Notice of Intent

Type of Action: APD Change

Top Spot KPLA Bulk Sundry

PECOS DISTRICT DRILLING CONDITIONS OF APPROVAL

4-String Design – Open Int 1 x Int 2 Annulus

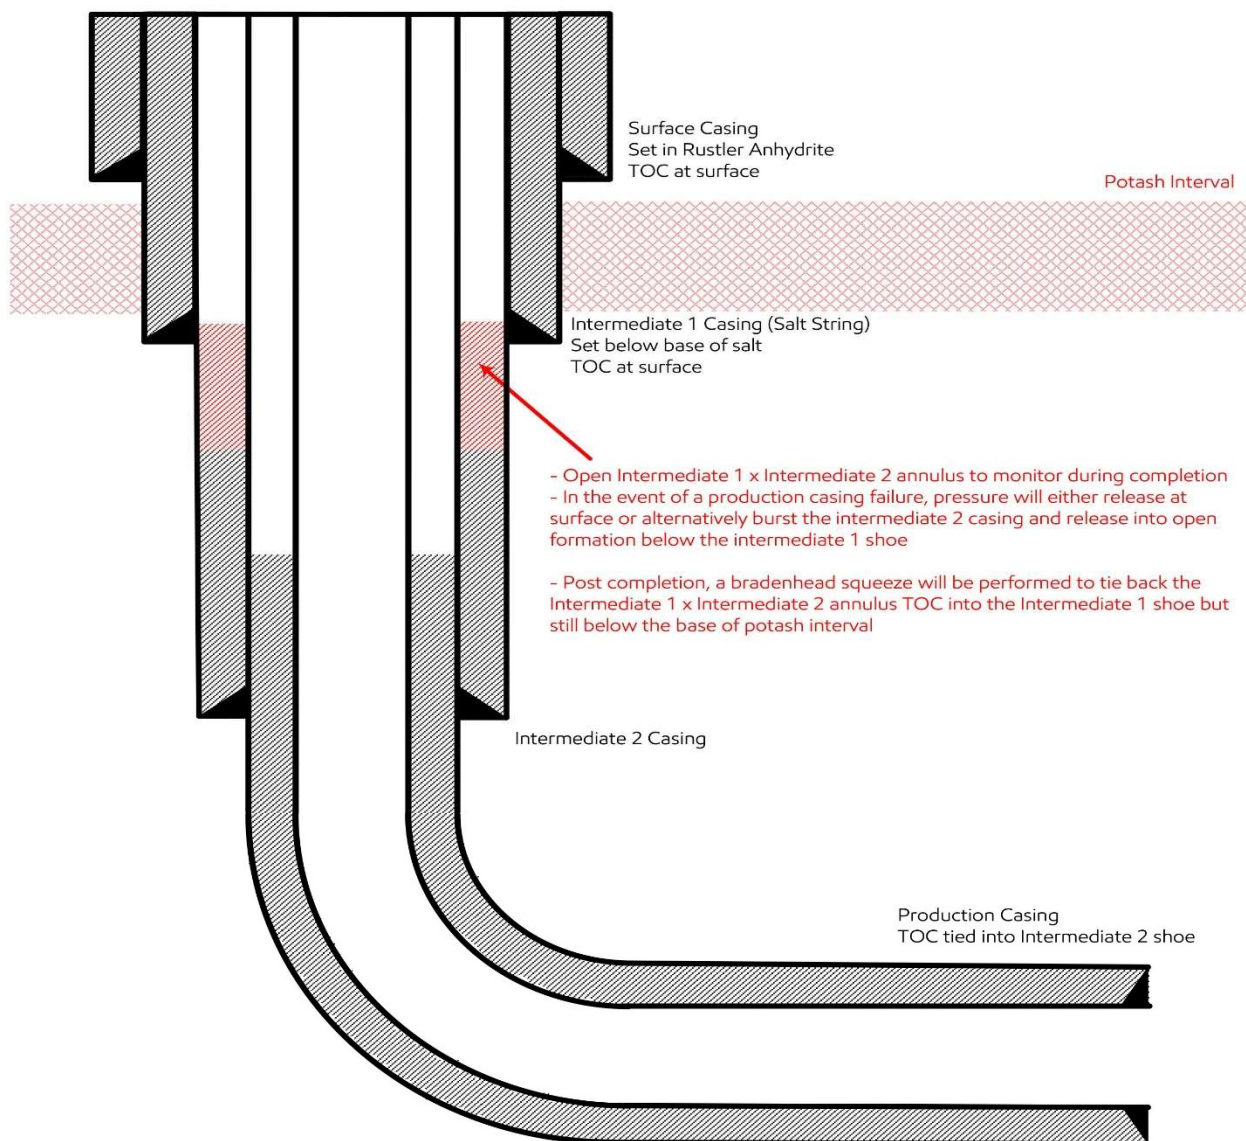
Oxy requests to update the Deep Intermediate Cement Job to align with the agreed upon R111-P updates presented from the JITC. I've included 4 tables below due to the different target benches:

**ALL PREVIOUS COAs STILL APPLY. CEMENT DESIGN UPDATE AS PER
KPLA BEST PRACTICES (4-STRING INT1 X INT2 OPEN ANNULUS)**

Operator has proposed to pump down 7-5/8" X 9-5/8" annulus POST-FRAC. Operator must top out cement after the bradenhead squeeze and verify cement to surface. Operator can also check TOC with Echo-meter. CBL must be run from TD of the 7-5/8" casing to surface if confidence is lacking on the quality of the bradenhead squeeze cement job. Submit results to BLM.
